STAFF REPORT 10-9-2019 MEETING
APPLICATION NUMBER 19-6494
ADDRESS: 267 E. GRAND RIVER
HISTORIC DISTRICT: MADISON HARMONIE
APPLICANT: JANET FORD
DATE OF COMPLETE APPLICATION: 9/18/2019
DATE OF STAFF SITE VISIT: 10/1/2019

SCOPE: REHABILITATE BUILDING

Re: HDC Submittal Info - Harmonie Club Building, 267 (aka 311) East Grand River Ave., Detroit, MI

VIEW DIAGRAM - SITE

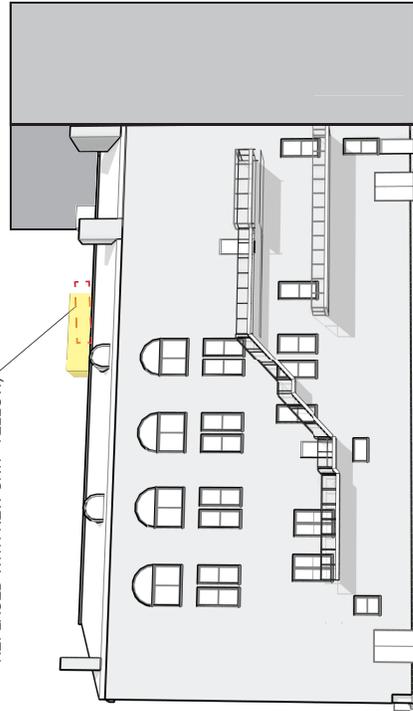
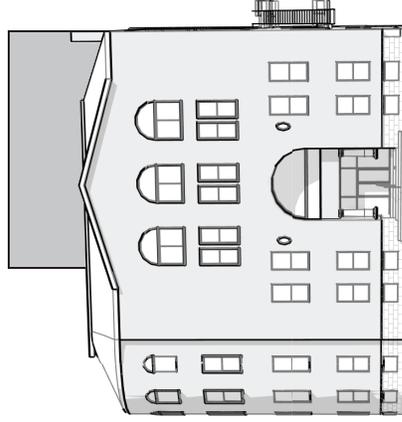
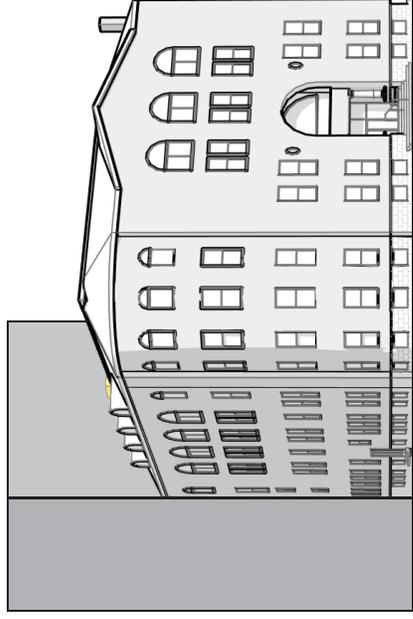
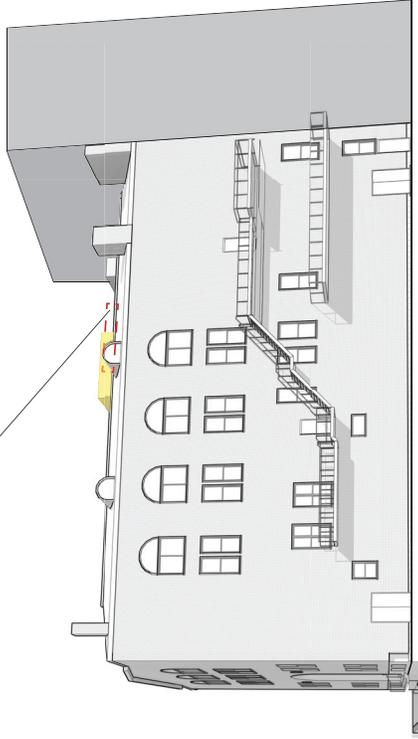
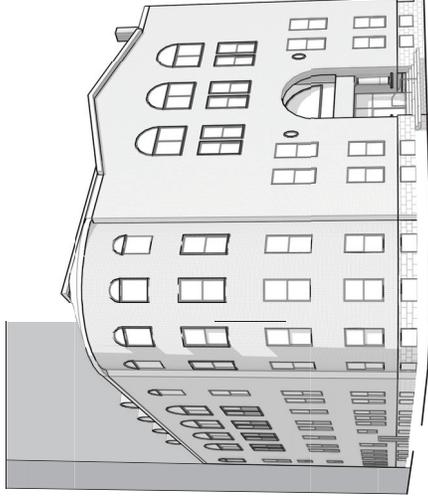
- Replace the current small rooftop HVAC unit with a new unit. See the view diagrams for visibility from the right-of-way (ROW). The unit cannot be seen from the immediately surrounding ROW. However, it will be seen across the parking lot from Madison, as can the existing unit.
- Replace existing roof membrane with a new EPDM membrane
- Replace all existing standing seam metal roofing (including mansard roof and dormers) with new metal roof to match existing. Finish color green to match the trim/window color
- Repair the existing integral gutter. Replace portions that are damaged beyond repair with matching materials
- Remove plywood from dormers and replace existing vents with new vents to match existing (finish color green to match trim)

1. Because the current HVAC and electrical systems are undersized for the restaurant and event space assembly uses, a new rooftop unit will be replacing the small unit which currently exists. See the view diagrams for visibility from the r.o.w. The unit cannot be seen from the immediately surrounding r.o.w.s. It will be seen across the parking lot from Madison, as can the existing unit.
2. Most of the existing smaller furnaces on each floor will remain or be relocated, but are not currently supplied by fresh air, therefore new exterior grilles will be required, one on the south elevation. It is proposed to replace the upper sash of the small window within the existing mechanical room. All other new openings we were able to locate on the alley side, mostly within former window openings that had been bricked-in.
